PROJECT **123A90 - HOLLANDSE KUST NOORD WIND PARK**
BLPH Project

MECHANICAL COMPLETION DOSSIER (ONSHORE)

Junction Box 950-JE-02102 and Multi-core cable (FGS System)

PUNCH ITEM ENTRY / CLEARANCE FORM

C30002516

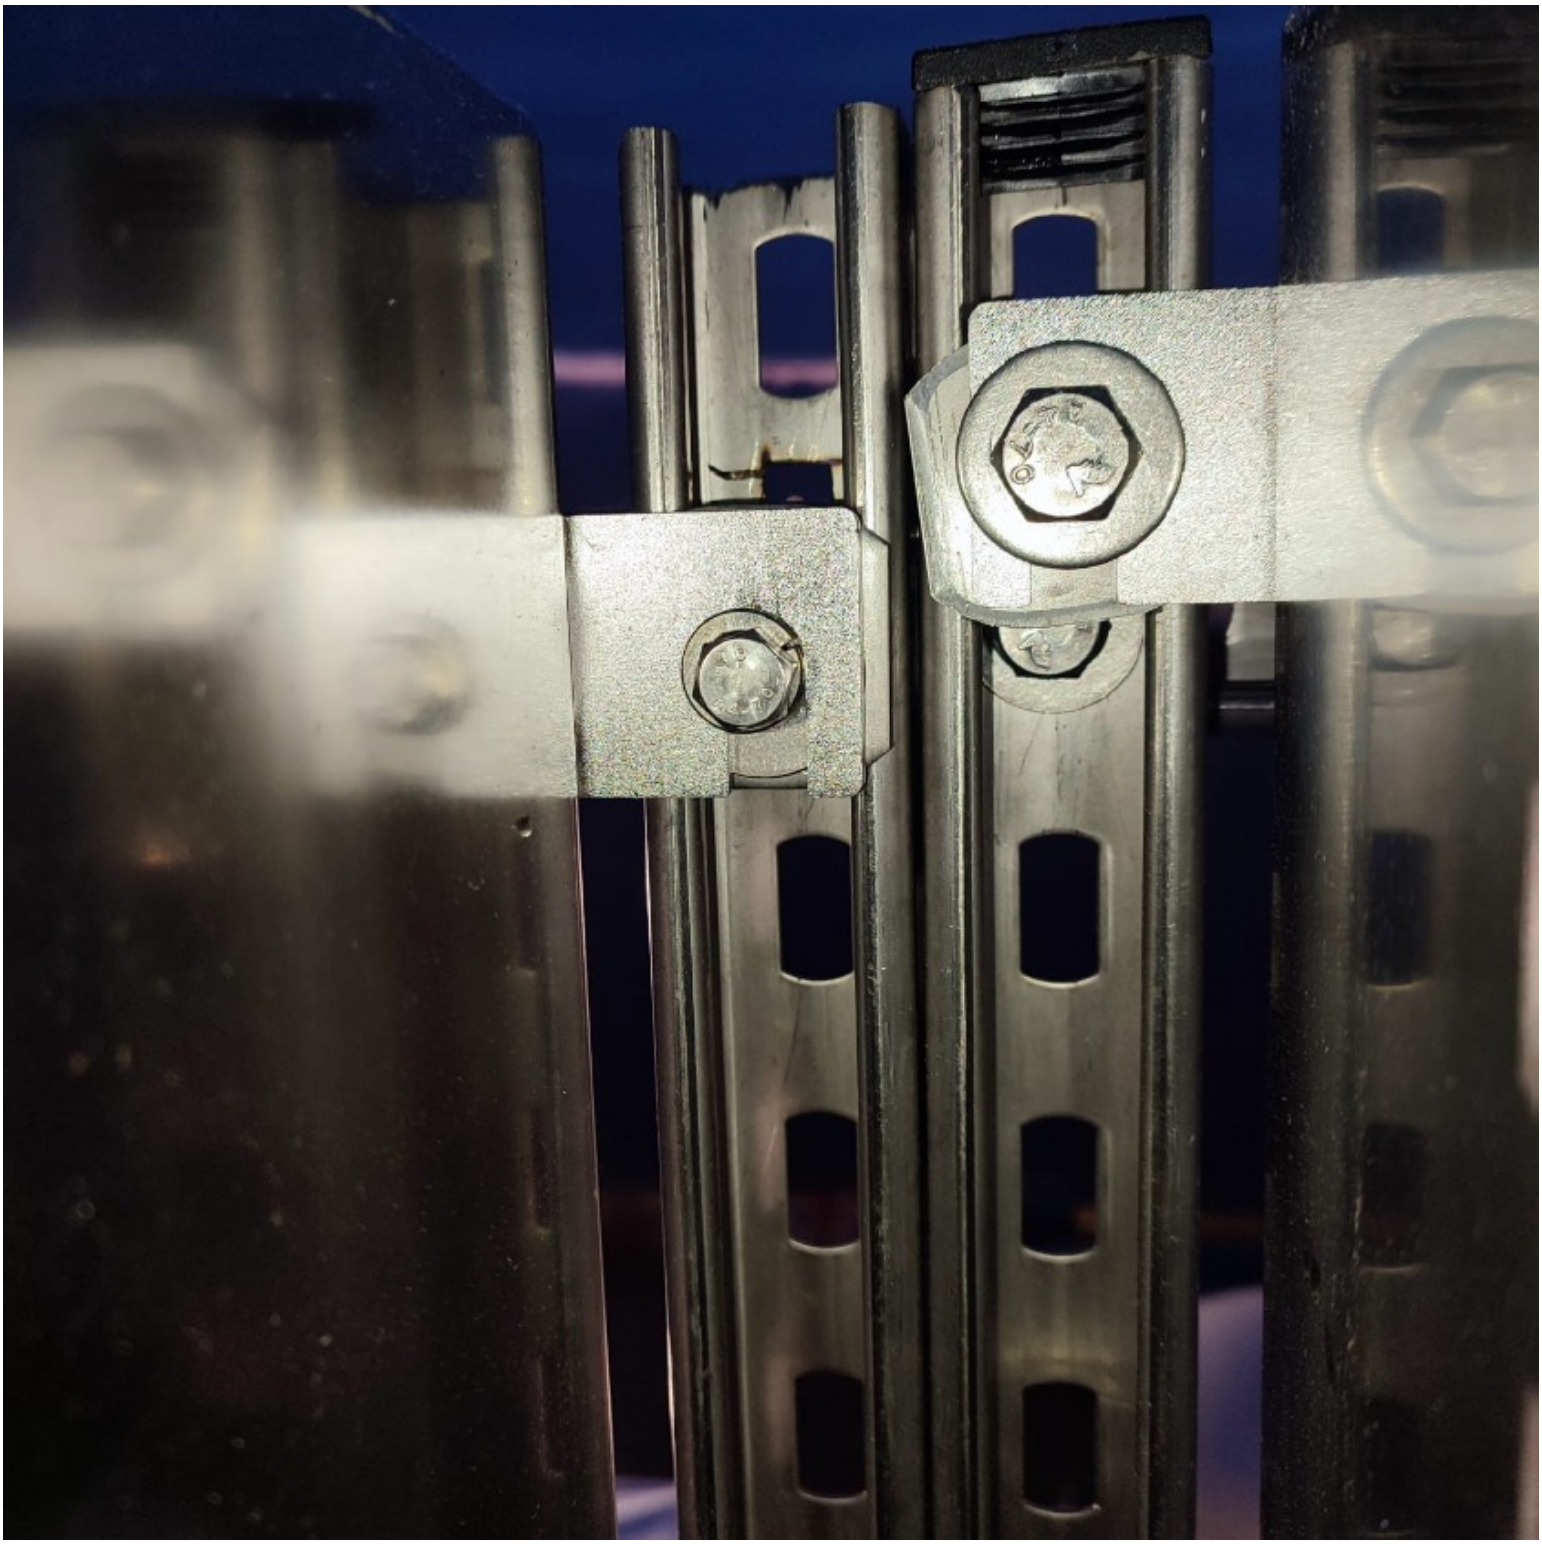
Missing All growers of the support JB. See attached photo.

DONE

C30002530

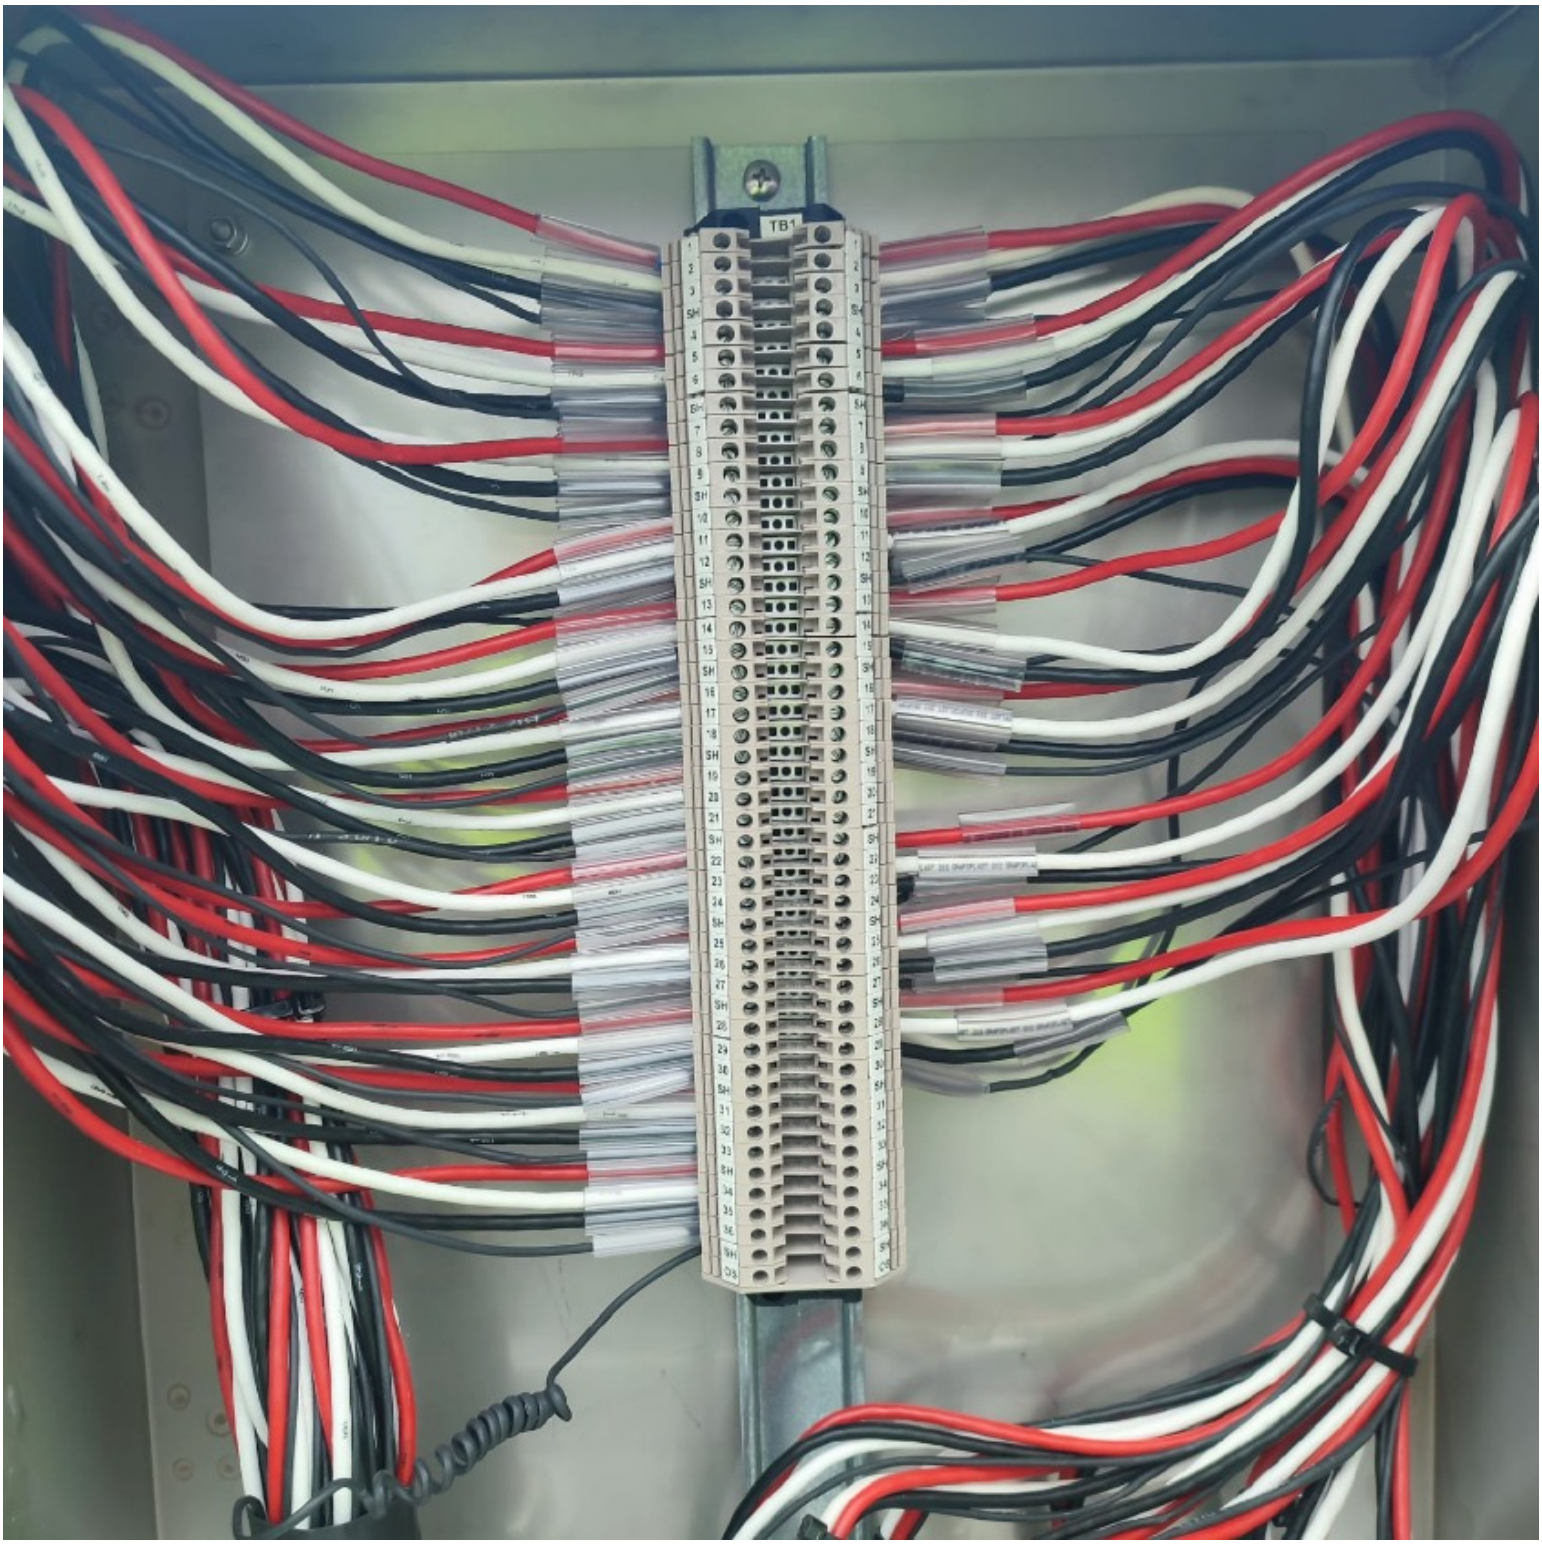
Missing grafoplast and tag wire on the shield, inside the (950-JE-02102).See attached photo.

Installed.

C30002531

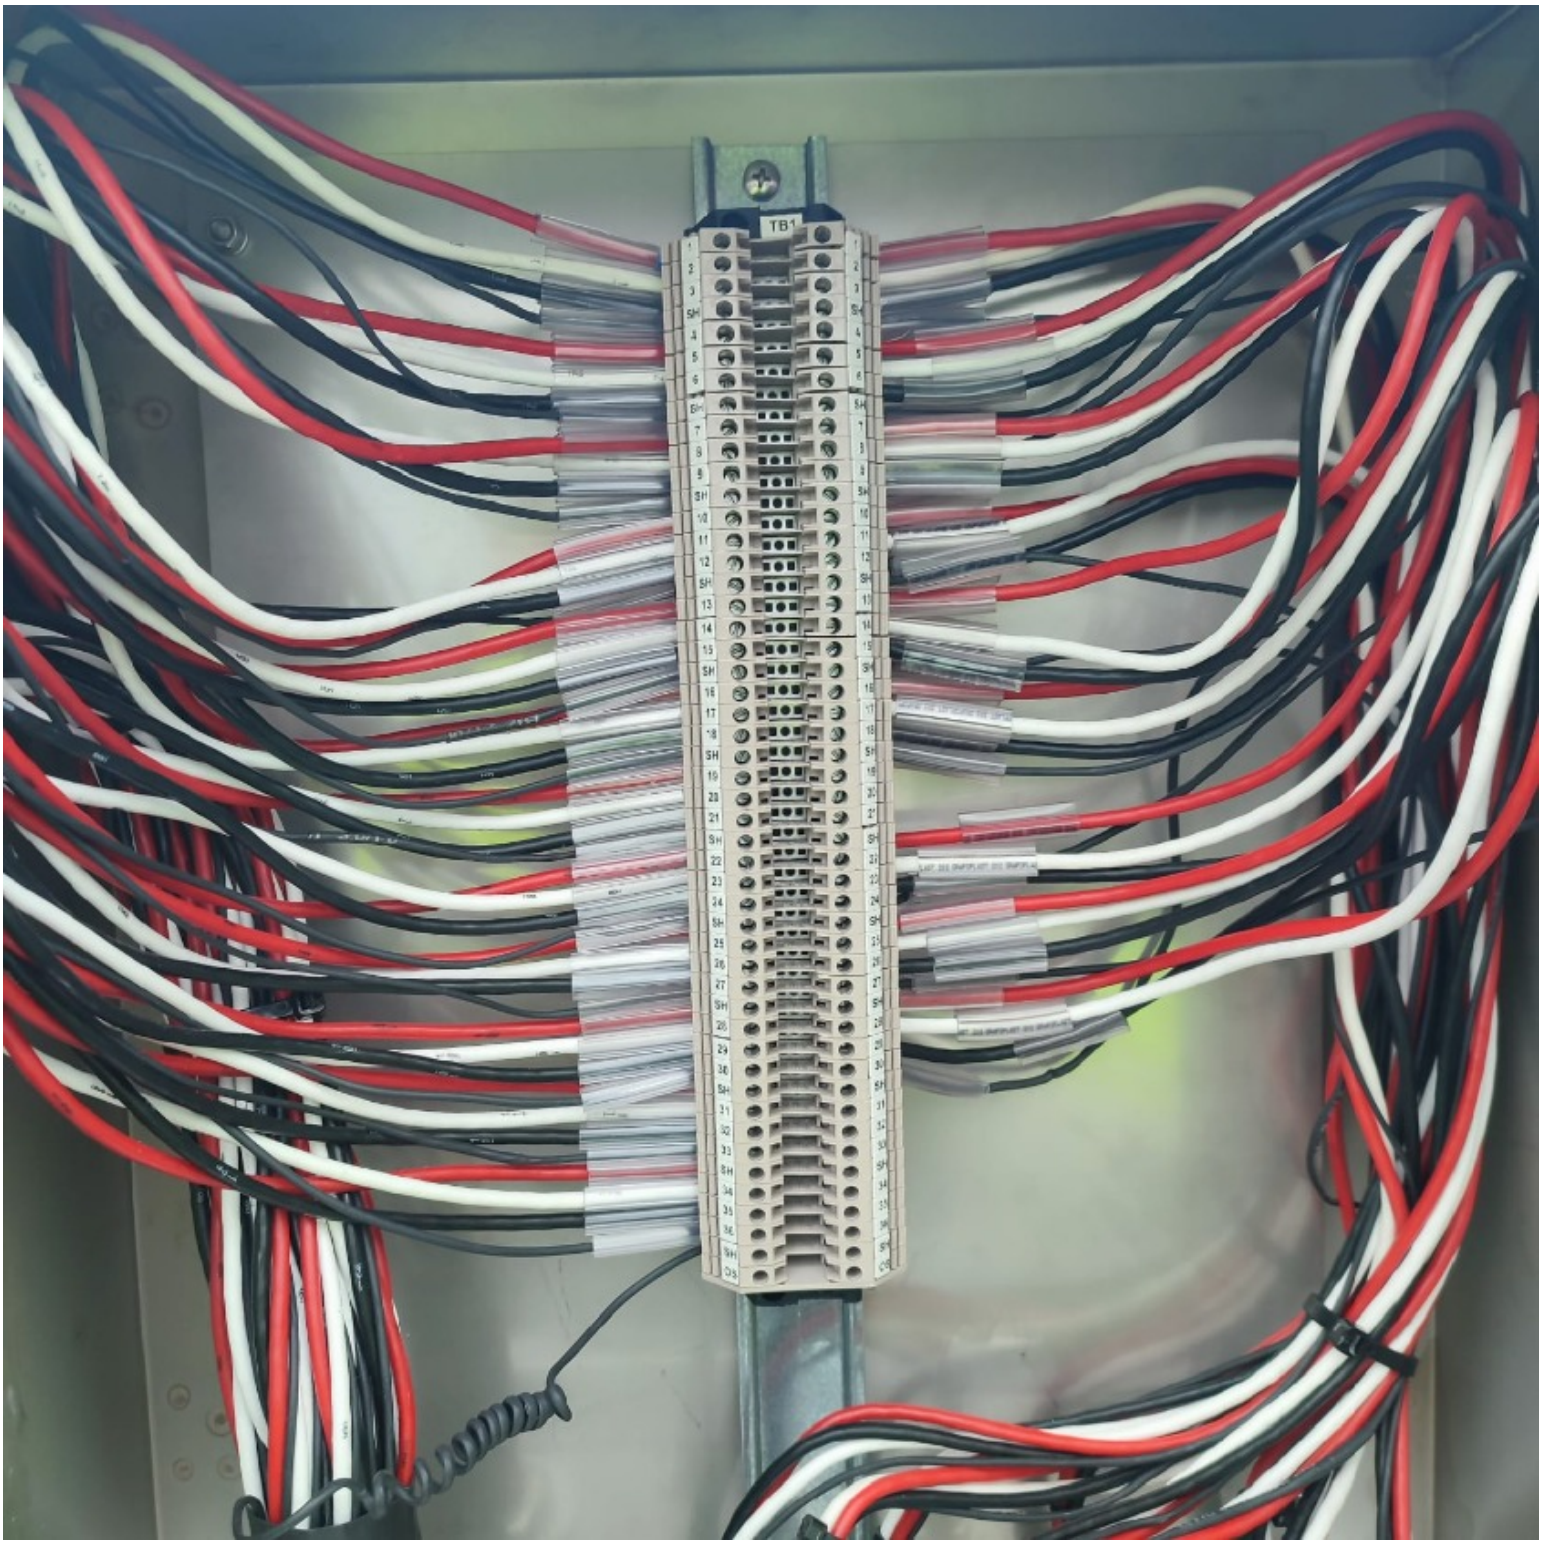
Core identification tags are missing on 00-JE-02102 side and are wrong on side B400-FGS-003 . See attached photo.

Core indentification now is correct.

C30002533

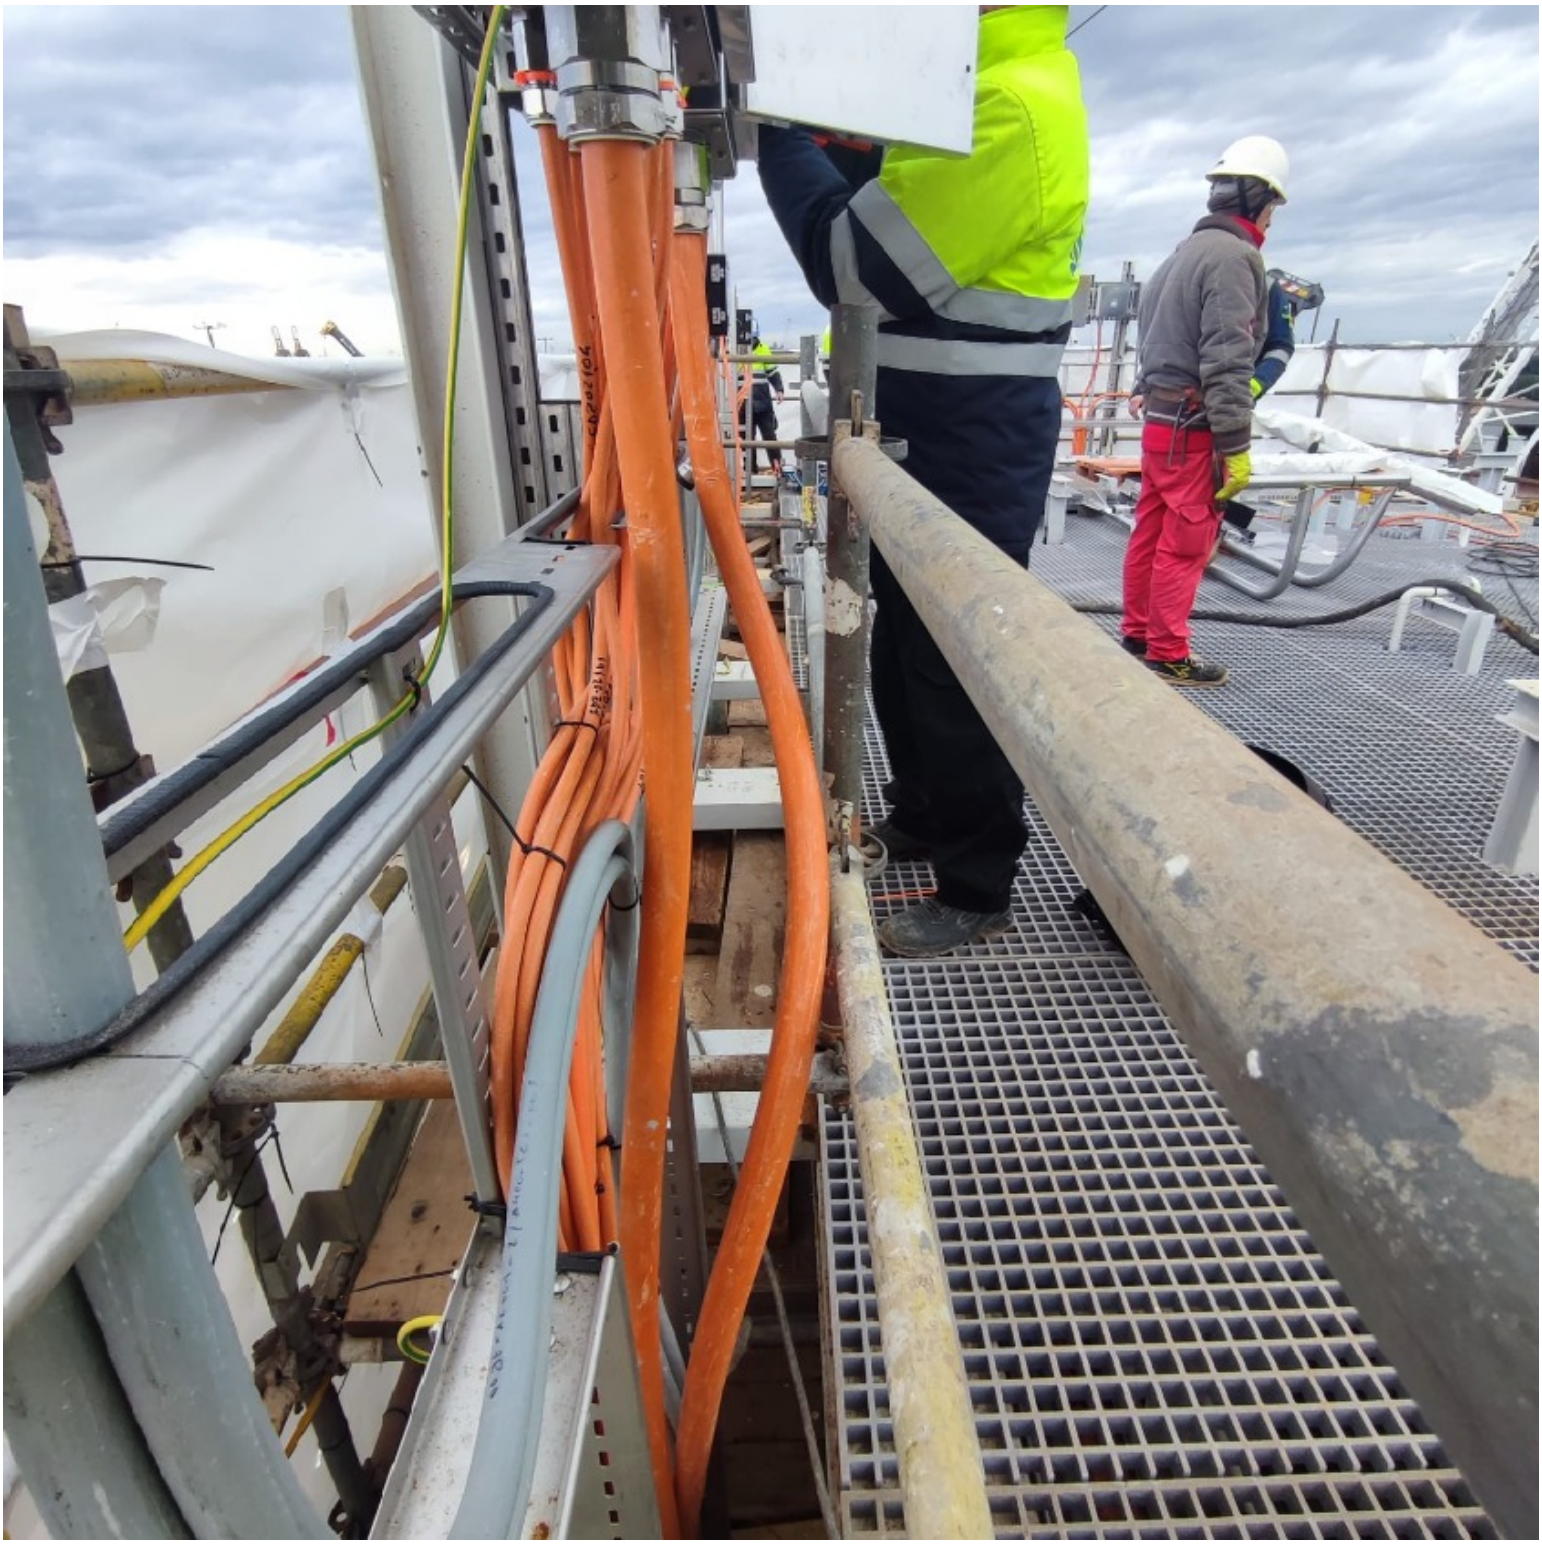
Missing cable tag side the (950-JE-02102).See attached photo.

DONE
